Patent No.: 6,400,126 B1

Title : SWITCHING REGULATOR WITH MULTIPLE POWER TRANSISTOR

DRIVING VOLTAGES

TRANSMITTAL OF REQUEST FOR CERTIFICATE OF CORRECTION

In Sheet 1 of the drawings, FIG. 4 should appear as follows:

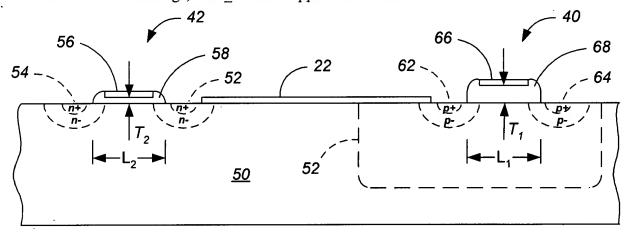
In Sheet 1 of the drawings, FIG._1, element 40 should show a PMOS symbol and element 42 should show an NMOS symbol.
